STATE OF HAWAII
DEPARTMENT OF TRANSPORTATION
HIGHWAYS DIVISION

INTERSTATE ROUTE H-1
Kunia Interchange Improvements
F. A. I. Project No. 1M-HI-1(219)

SHEET No. L35 OF 52 SHEETS

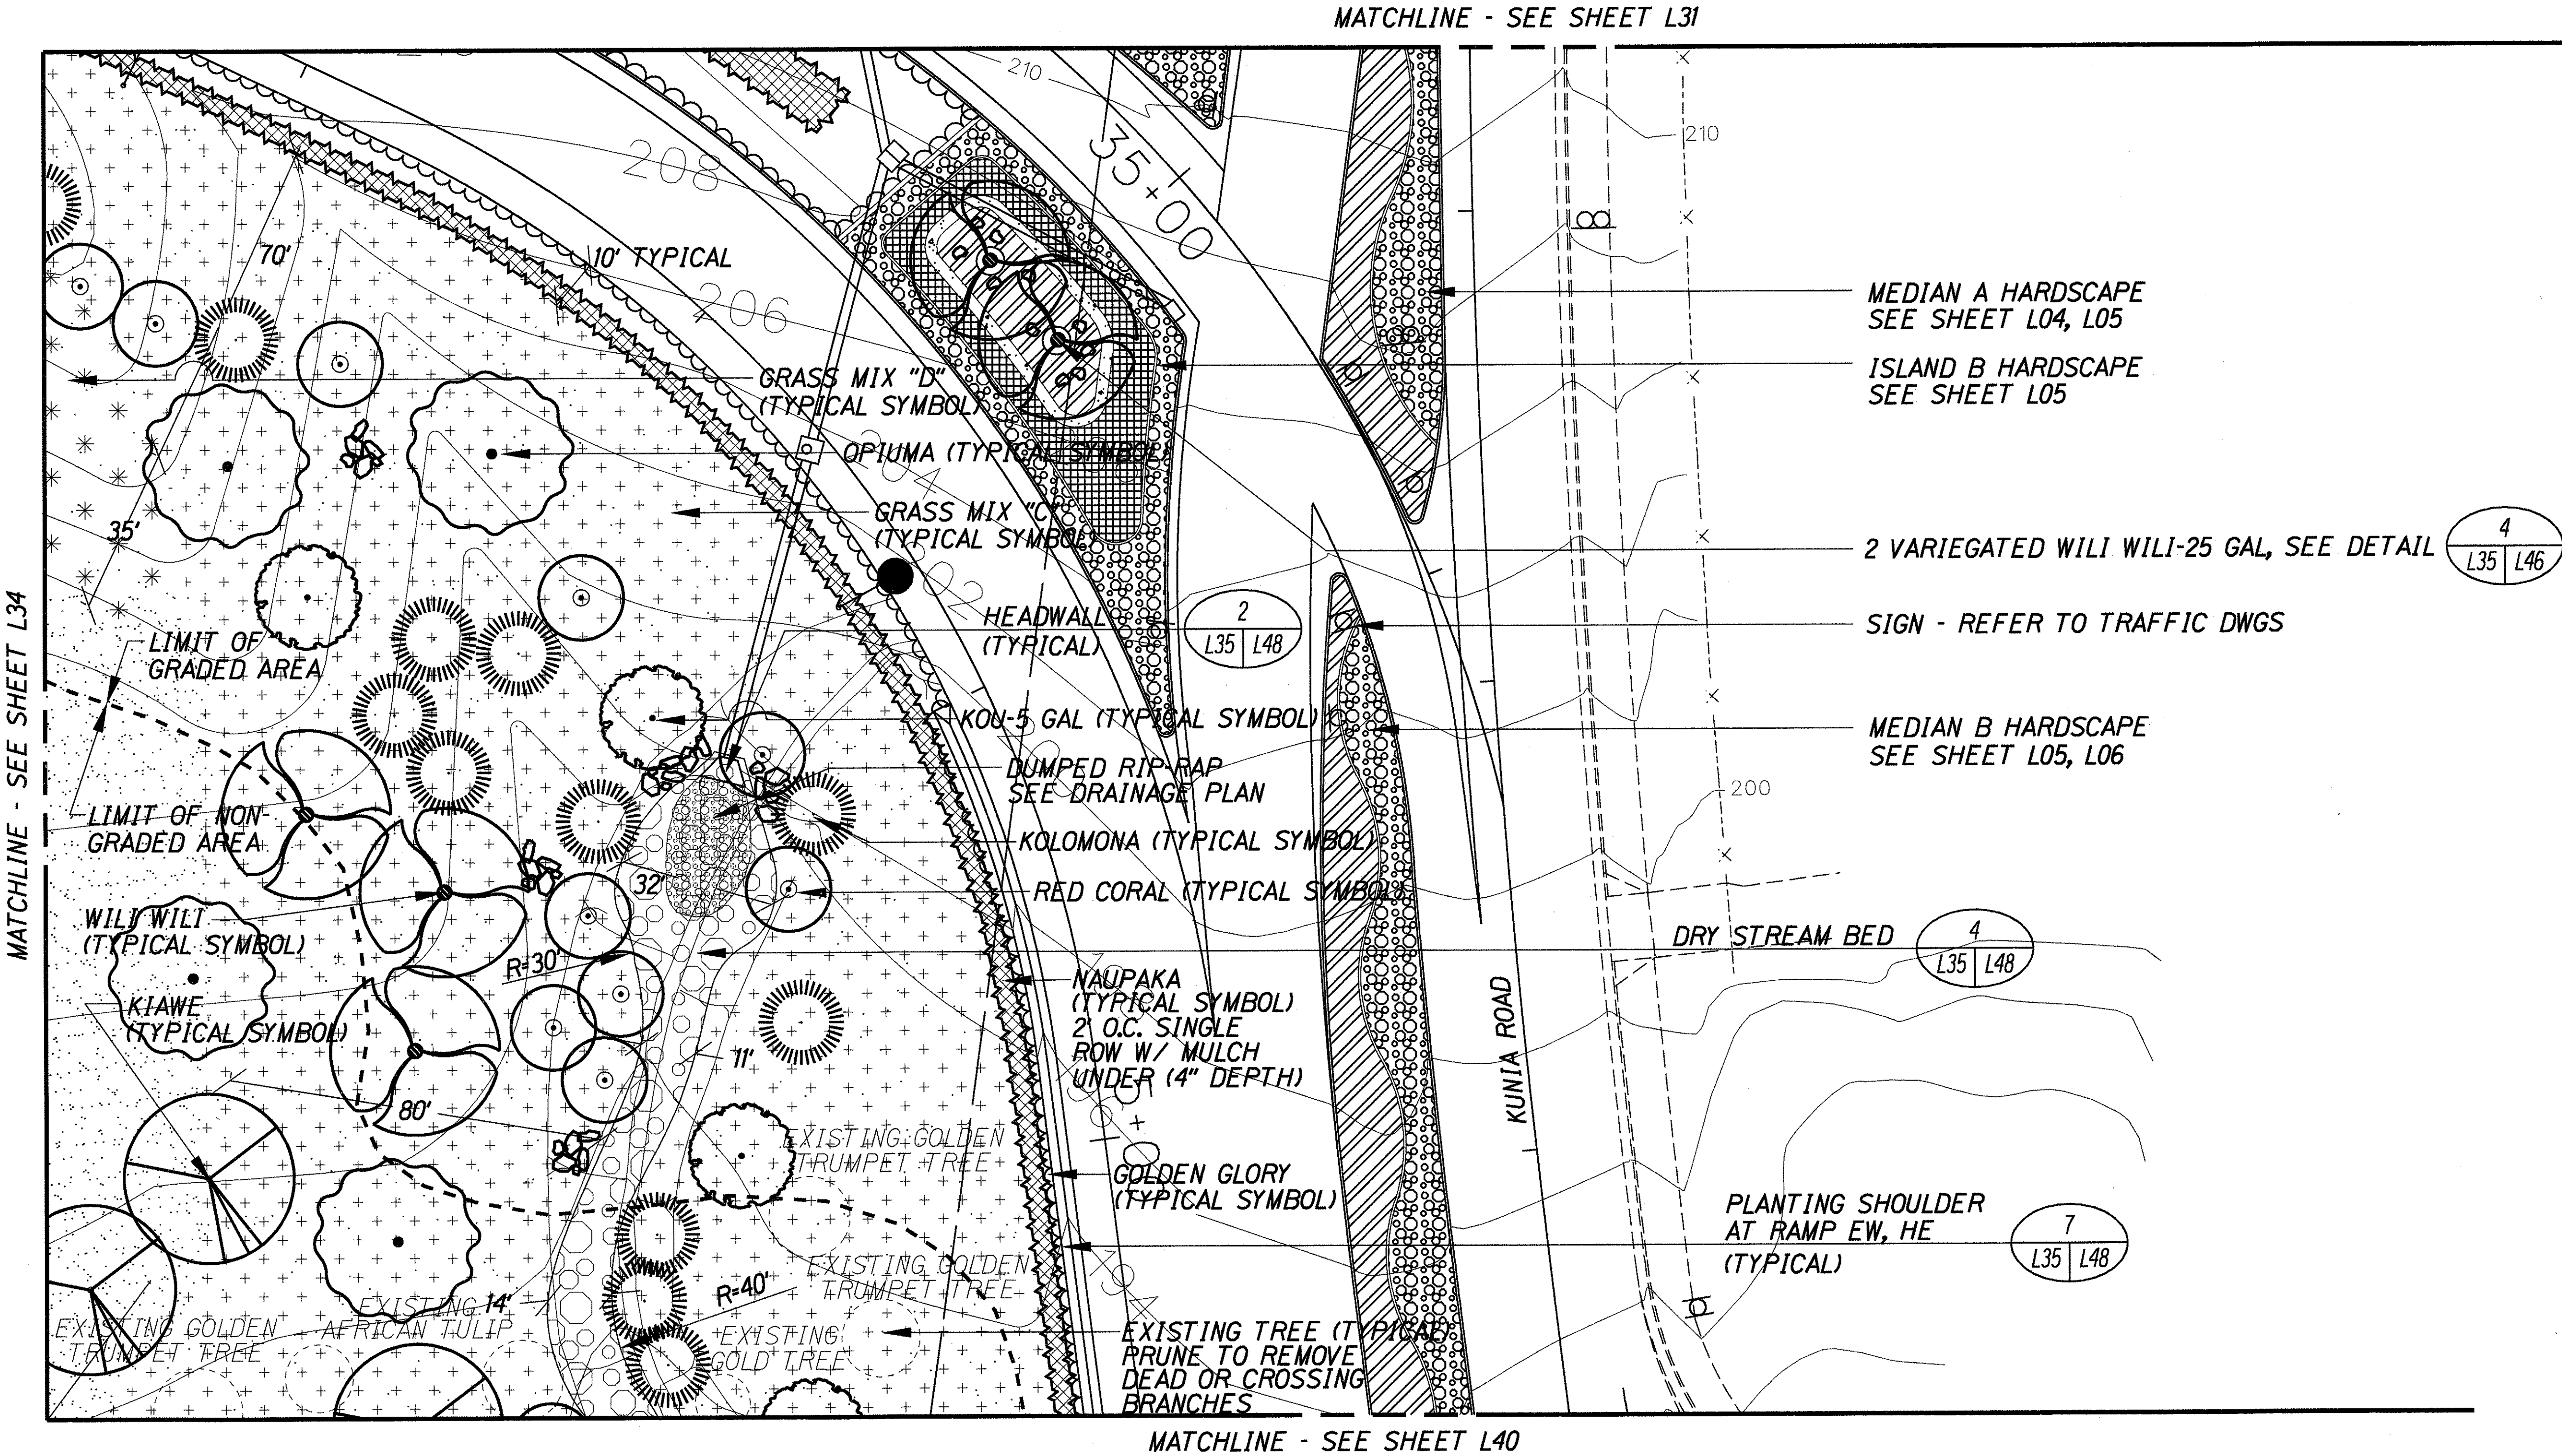
4/3/98	Revised Typical Symbol for Creeping Illima to Read Golden Glory Per Addendum NO. 3.
DATE	REVISION

SHEET No. L37 OF 52 SHEETS

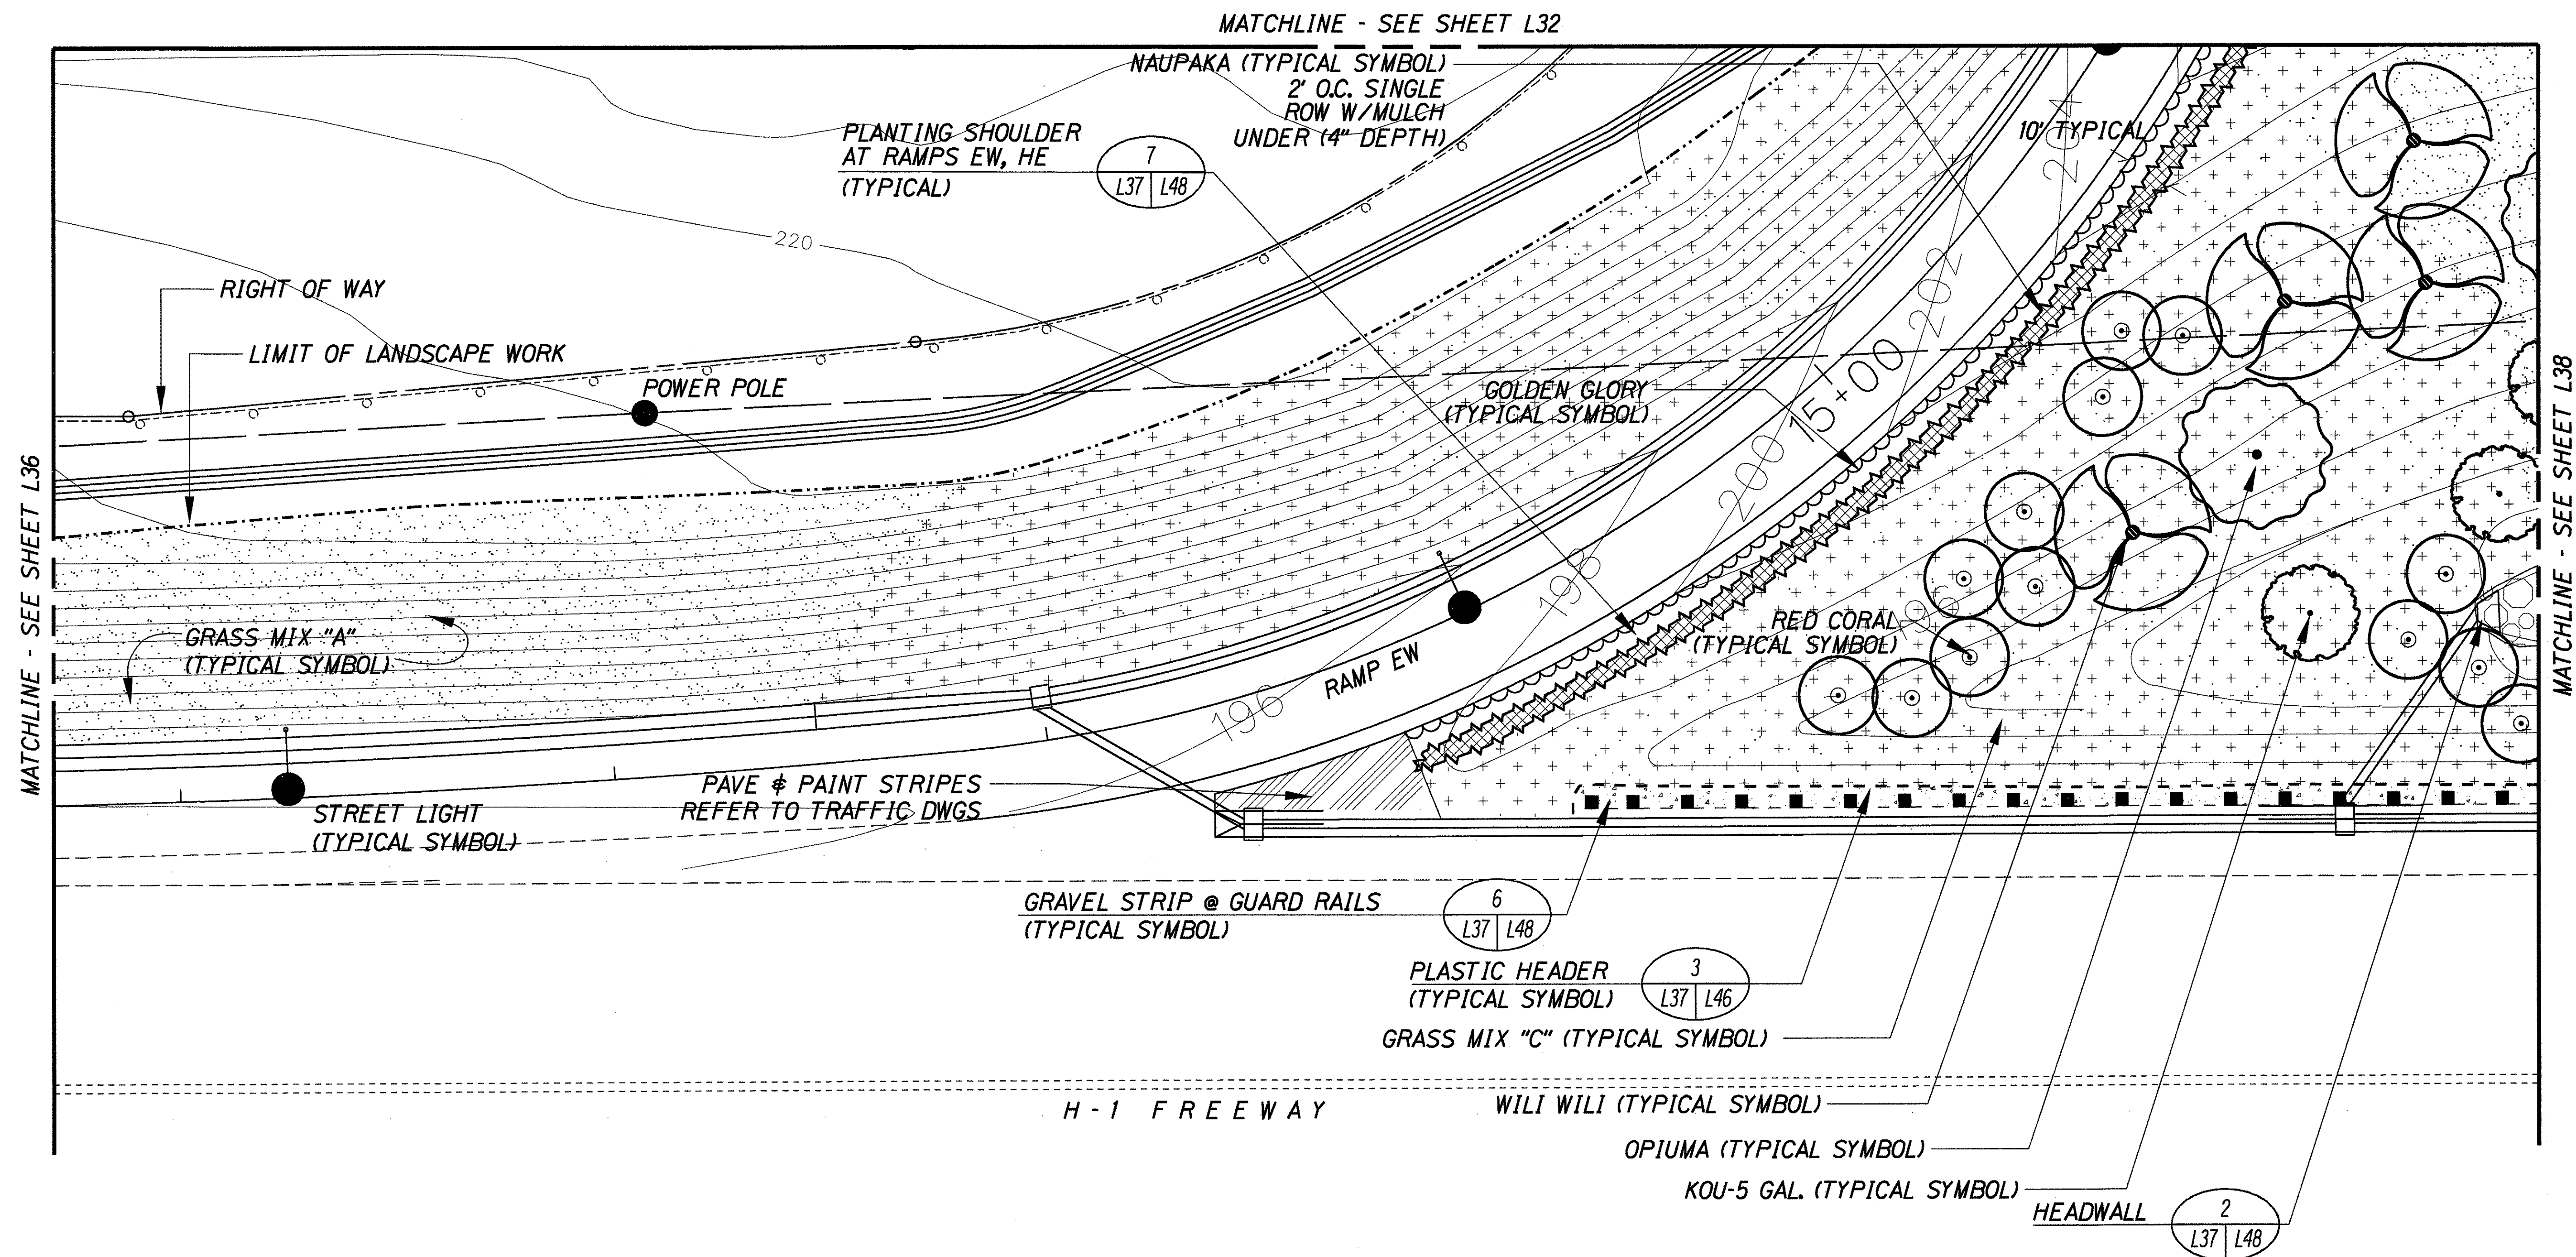
4/3/98	Revised Typical Symbol for Creeping Ilima to Read Golden Glory Per Addendum NO. 3.
DATE	REVISION

SHEET No. L38 OF 52 SHEETS

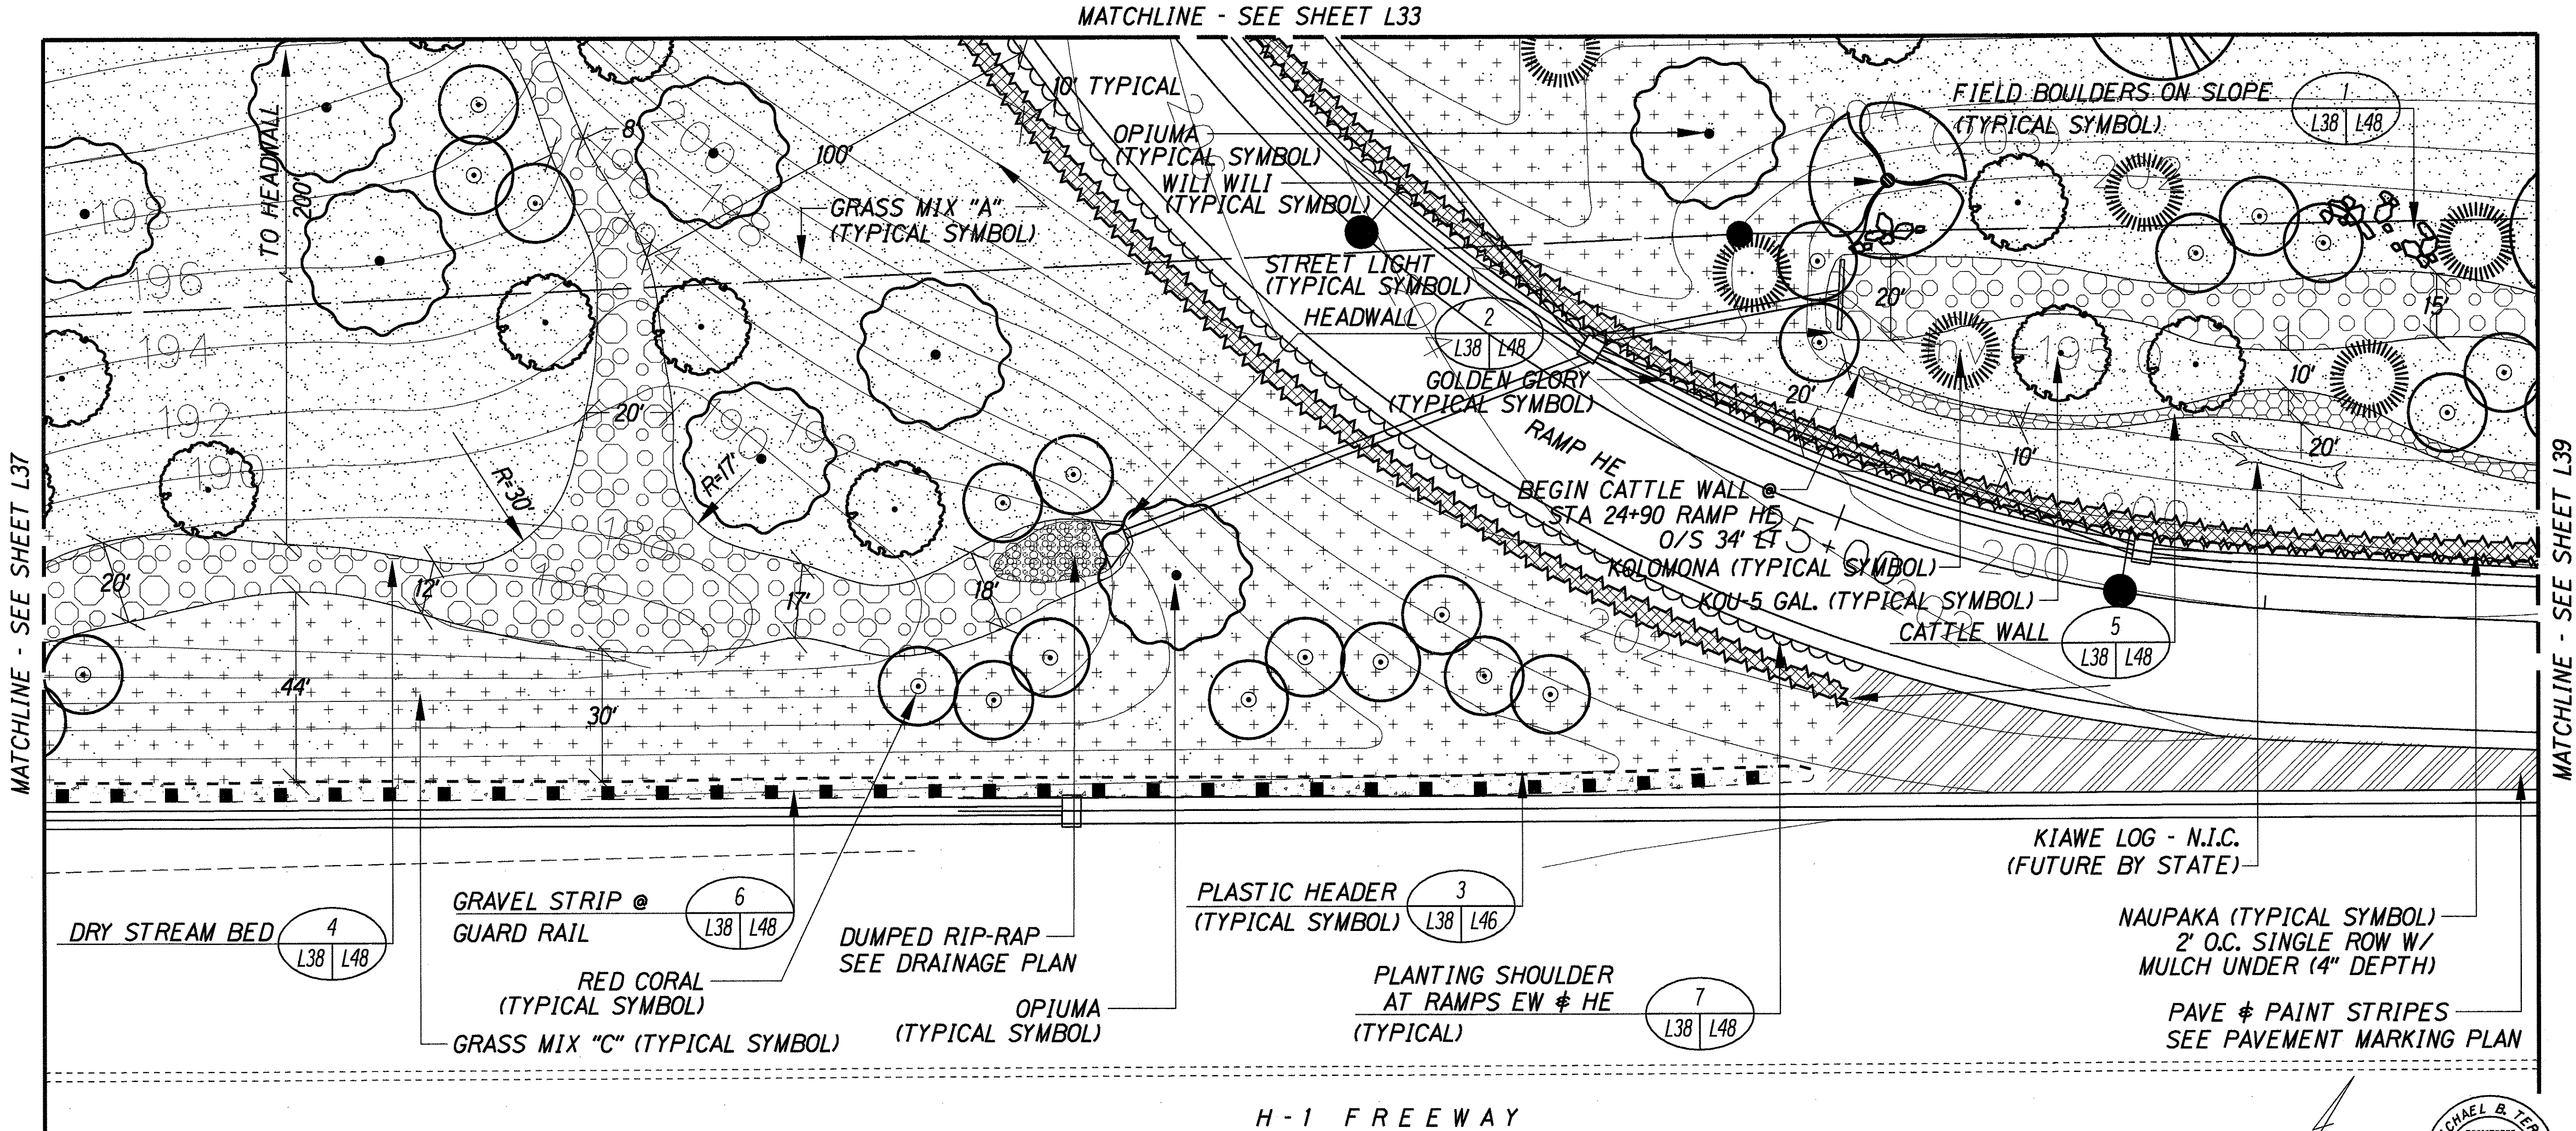
4/3/98	Revised Typical Symbol for Creeping Ilima to Read Golden Glory Per Addendum NO. 3.
DATE	REVISION
